बृहन्मुंबई महानगरपालिका
मुंबई अग्निशमन दल

विषय: Minutes of Meeting on PEATA / MCHI Representation.

SUB: MINUTES OF MEETING ON PEATA / MCHI REPRESENTATION

WINDOW SPRINKLER DETAIL

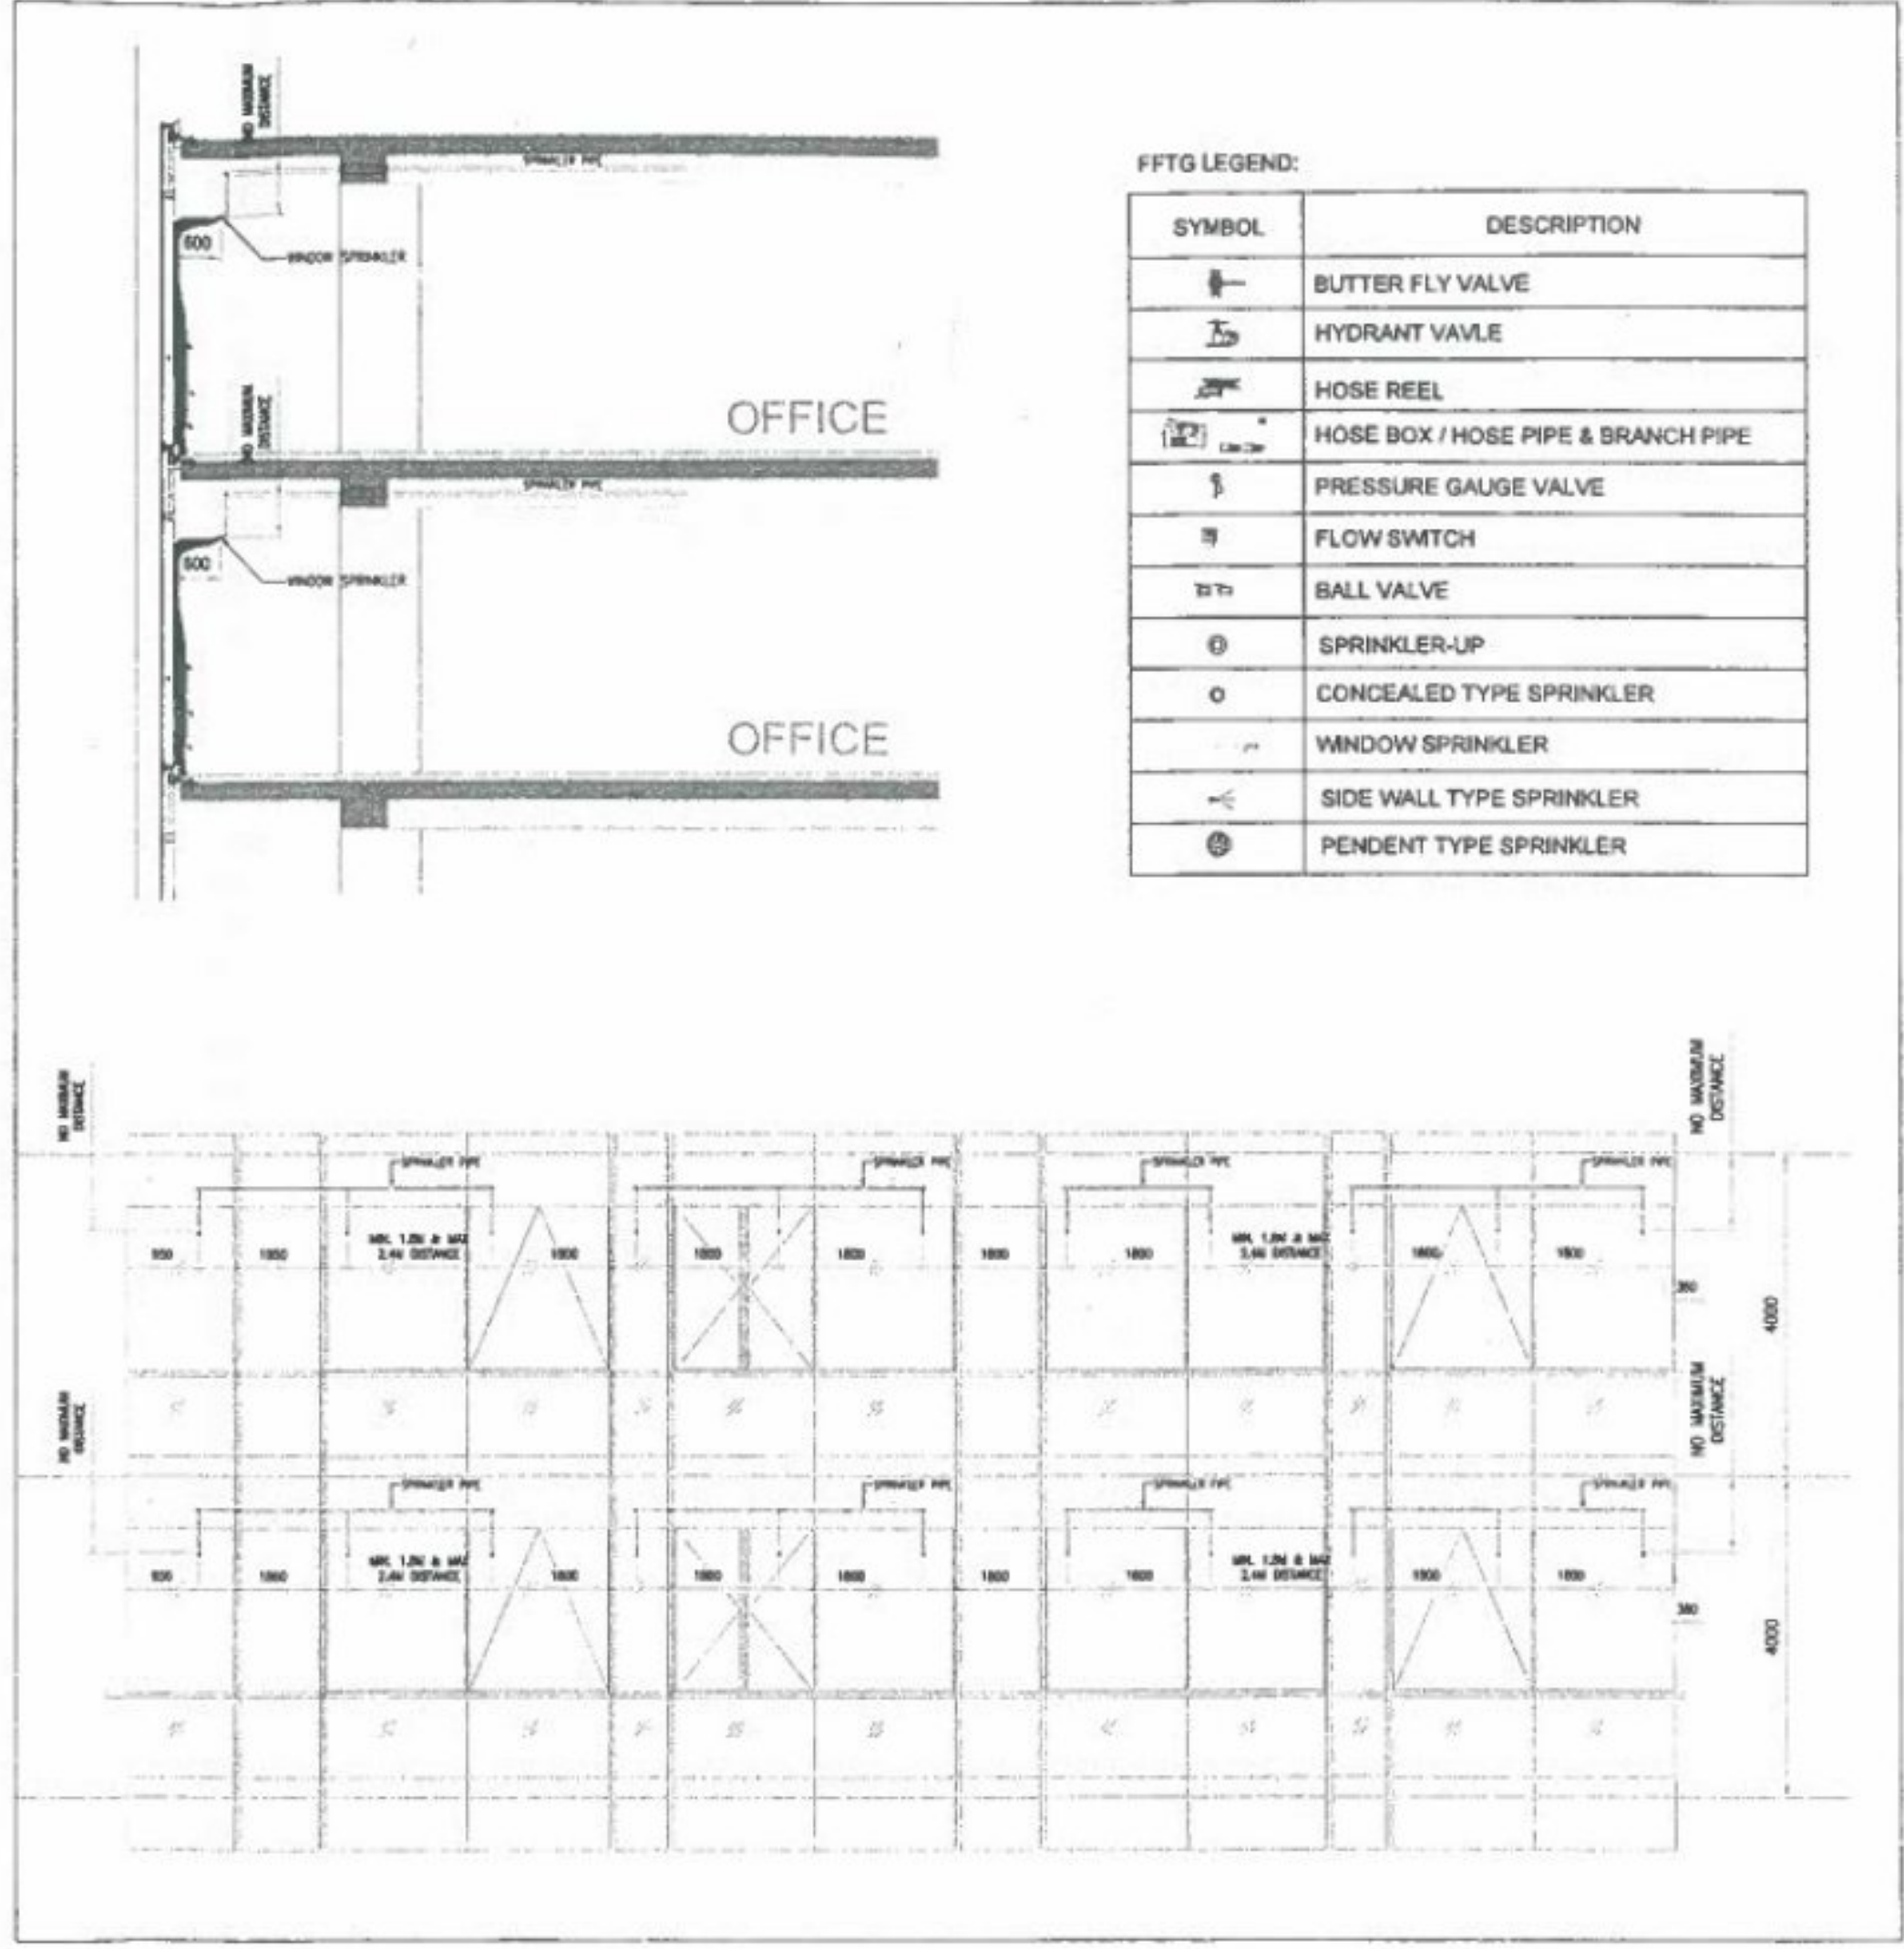
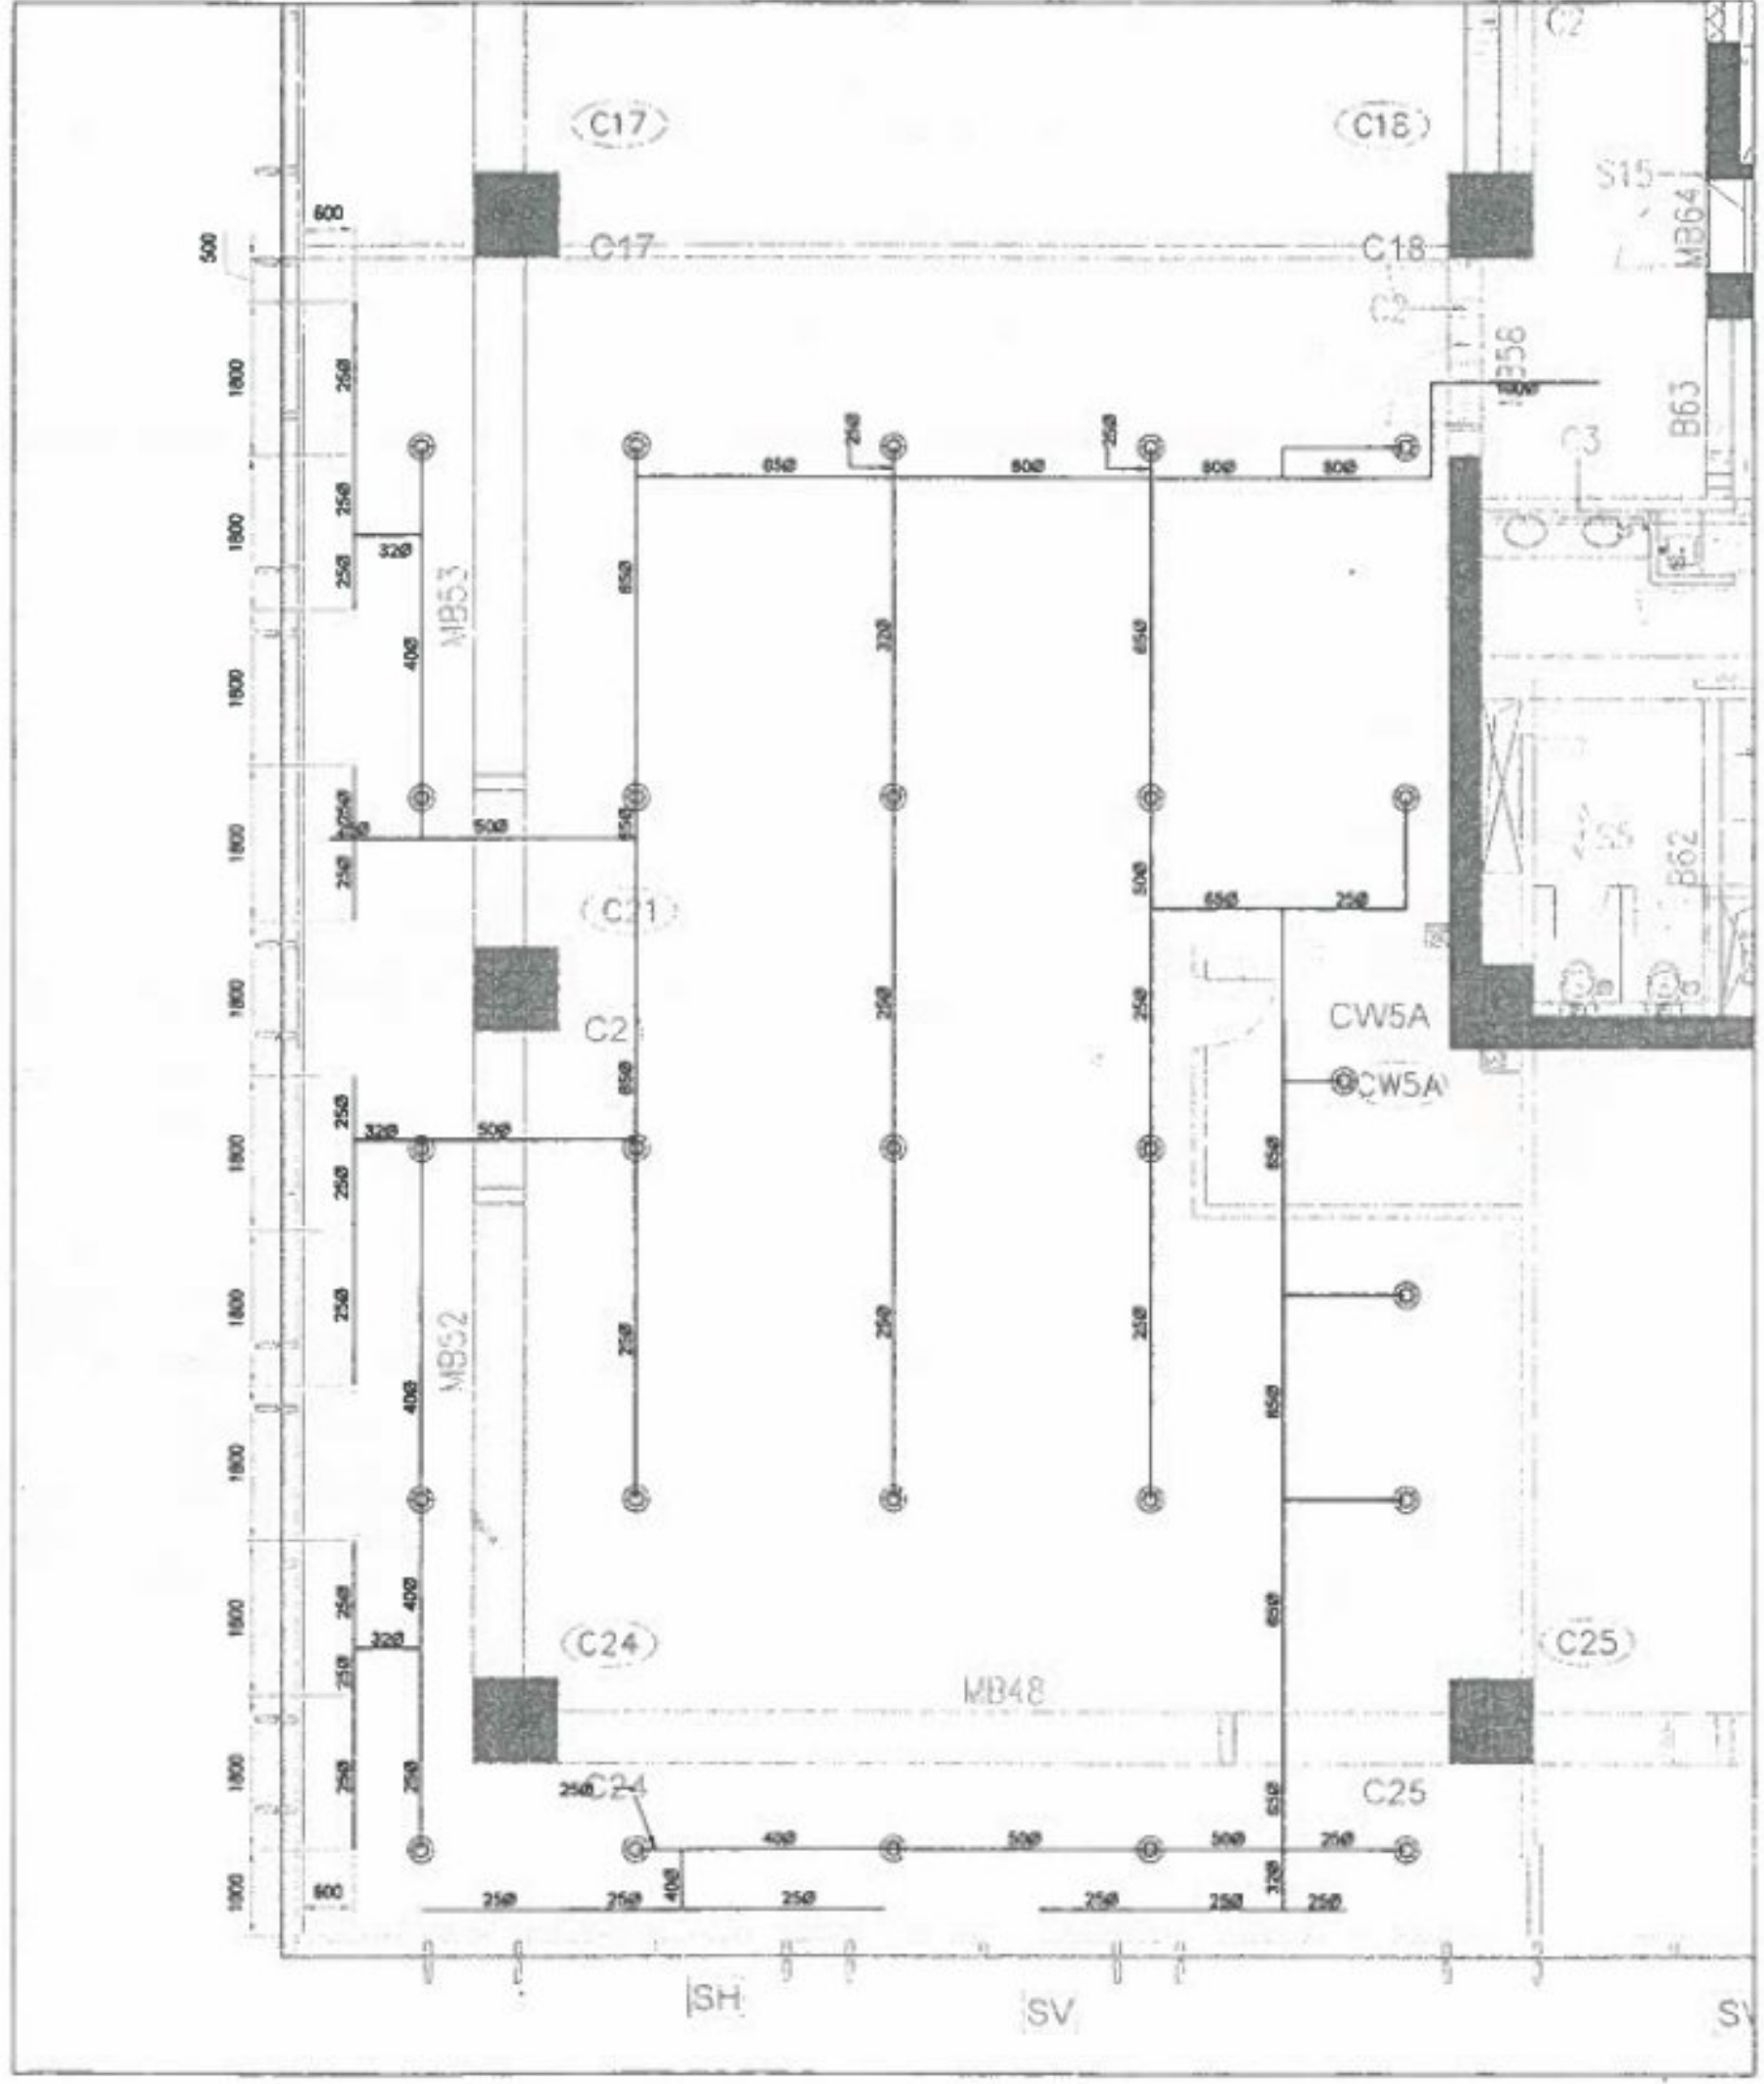
D Glass Façade			
9	Design & Provision of Glass Façade	Glass facade details shall be as per DCPR /NBC .	Agreedwith certification from MEPF consultant / Fire Safety Consultant as per NBC 2016 part 4 , clause 3.4.10.2.a in consonance with DCPR except existing glass facade buildings.
10	Provision of Sprinkler	Provision of Sprinkler at certain distance from Glass façade shall be allowed as per NBC.	Agreed
11	Provision of Drencher	Provision of drencher system is being insisted with-out giving reference to any of the code provision / NBC provision.	End of the Sprinkler arrays to be designed in a way to provide the complete linear coverage of the façade, distance between last

array of the sprinkler and façade should not be more than 600 mm centre to centre Distance for such sprinklers should not be less than 3.5 m (Sketch enclosed)
E Fire Tower & External Fire Evacuation System			
12	Provision of Fire Tower & External Fire Evacuation System as Reg. 48 (9)(B) of DCPR 2034	<p>As per DCPR Regulation 48 (9) (B) two type of systems any one of which provided shall be Agreed.</p> <p>Provision of Regulation reads as below:</p> <p><i>"For High Rise Building having height more than 70m shall be provided with <u>Fire tower</u> at Landing / Mid-landing Level with Smoke Check Lobby with Firemen's Lift being integral part of the Fire Escape Staircase <u>or Fire Evacuation Lift</u> (Hydropneumatics' / electrically operated) on external face of the building having opening within the fire escape staircase at landing / mid-landing level with smoke check lobby as approved by CFO shall be provided.</i></p> <p>Fire Tower if proposed shall be as per General arrangement of Fire Tower as per NBC and/or as per report of the expert Committee regarding Special Safety Regulations formulated by High Court in respect of Man made disasters.</p> <p>Fire Evacuation lift if proposed shall be as per General arrangement and shall be as per sketches approved by CFO</p>	<p>Agreed as per sketch enclosed.</p> <p>Fire Evacuation lift of min. load capacity of 1000 kg (for fresh proposals) if proposed shall be generally as per General arrangement and it shall be as per sketches enclosed so that double redundancy for the fire evacuation lift is achieved.</p>
